BRUNSWICK STEAM ELECTRIC PLANT, UNIT NOS. 1 AND 2
DOCKET NOS. 50-325 AND 50-324/LICENSE NOS. DPR-71 AND DPR-62
RESPONSE TO REQUEST FOR ADDITIONAL INFORMATION REGARDING
REQUEST FOR LICENSE AMENDMENTS - EXTENDED POWER UPRATE
(NRC TAC NOS. MB2700 AND MB2701)

Response to Request for Additional Information (RAI) 14

Response to Request for Additional Information (RAI) 14

Figure 1 - BSEP Design Basis LOCA Short-term Containment Pressure Response

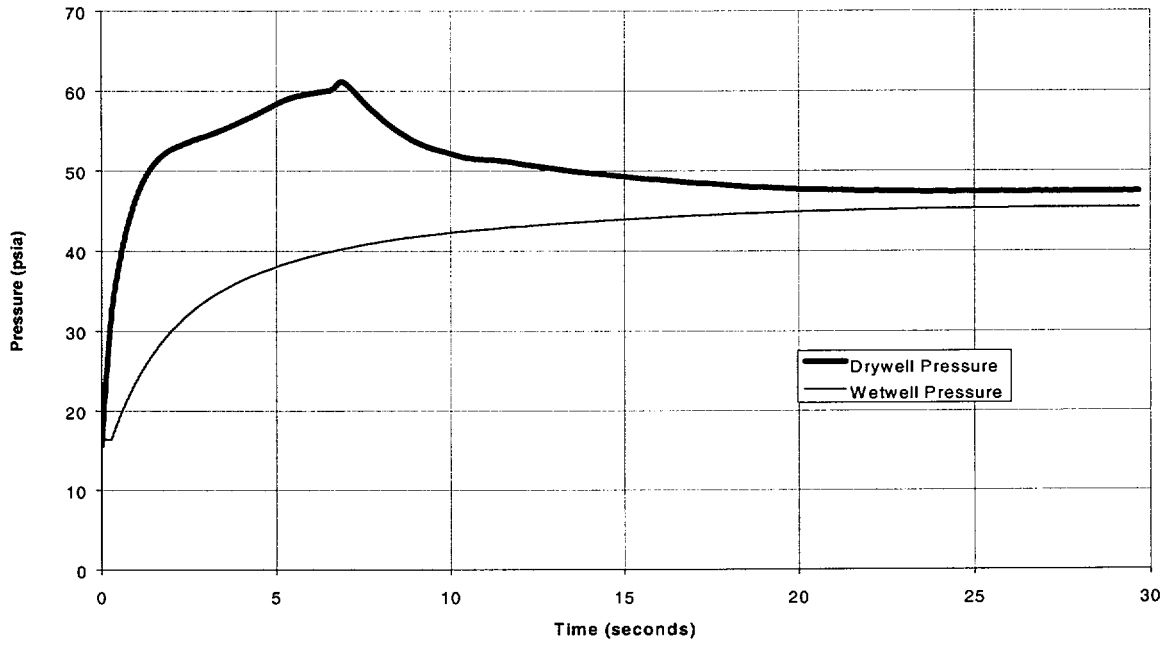
NRC Question 14-1

Please provide the peak pressure and temperature curves for the EPU analyses. (PUSAR Table 4-1 provides the peak values for DBA-LOCA.).

The design basis Loss-of-Coolant Accident (LOCA) containment responses are plotted in Figures 1 through 4. Figures 1 and 2 provide the short-term responses, which determine peak drywell pressure and temperature. Figures 3 and 4 provide the long-term responses, which determine the peak wetwell airspace and suppression pool temperatures; as well as the wetwell secondary peak pressure.

Figure 5 - BSEP 0.75 ft² Steam Line Break Containment Temperature Response

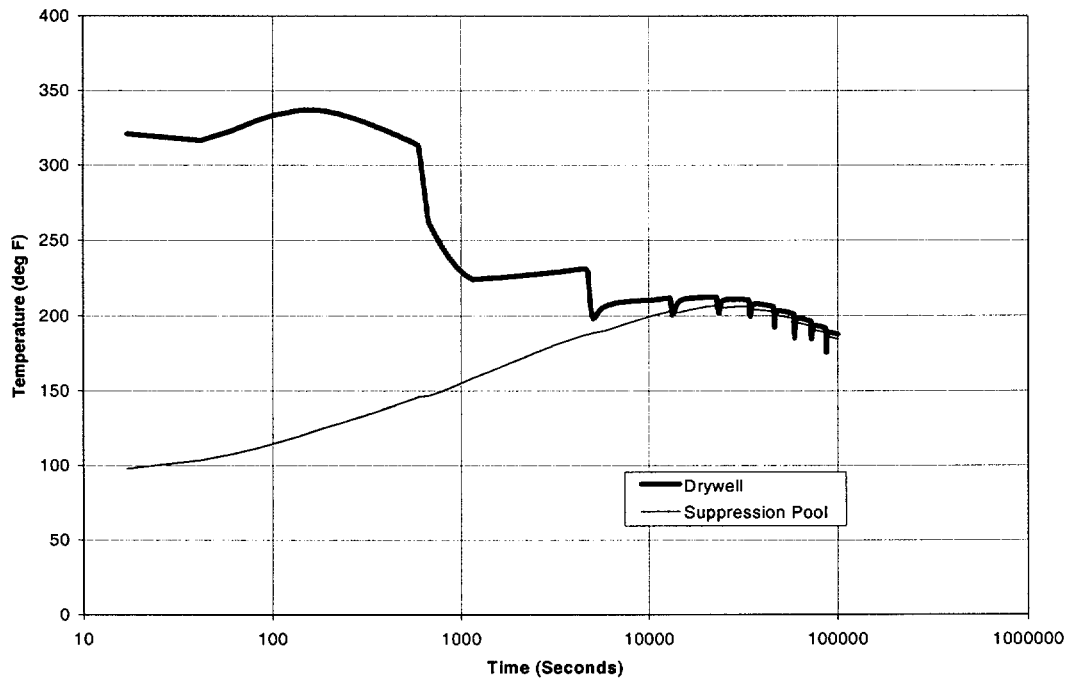
NRC Question 14-2

Please provide the peak temperature values for steam line breaks and wetwell pressure for NPSH evaluation.

For the EPU evaluation, four steam line break sizes were analyzed: 0.01 ft², 0.1 ft², 0.3 ft², and 0.75 ft². Figure 5 shows the drywell and suppression pool temperature responses to the 0.75 ft² steam line break, which resulted in the highest peak drywell temperature of 338.1°F among the four break sizes. The wetwell pressure response is plotted in Figure 6.

Figure 7 - Uncontrolled Drywell Hydrogen and Oxygen Concentrations for EPU

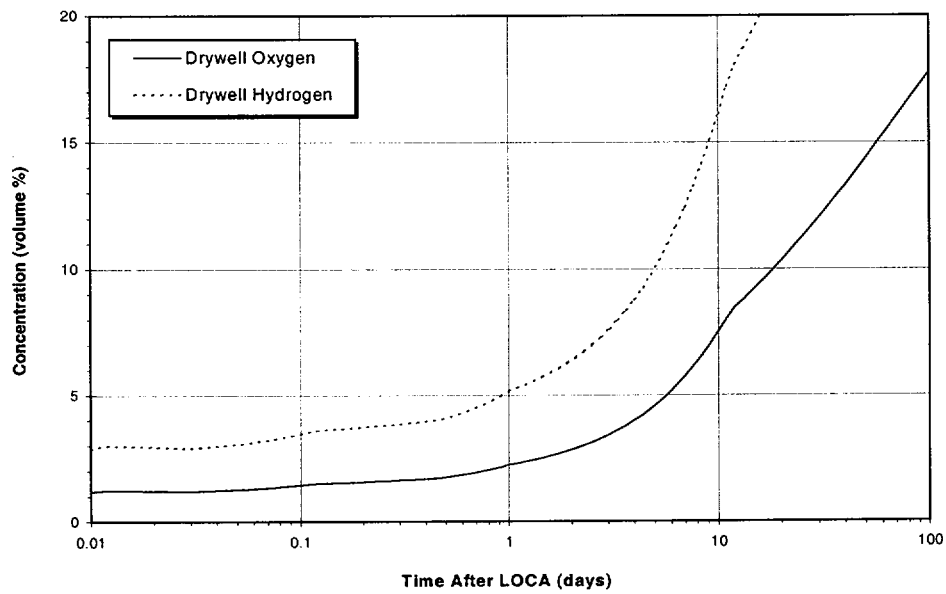
NRC Question 14-4

For Post-LOCA Combustible Gas Control in Section 4.7, please provide the hydrogen and oxygen concentration curves following a LOCA,

Figures 7 and 8 provide the requested curves.
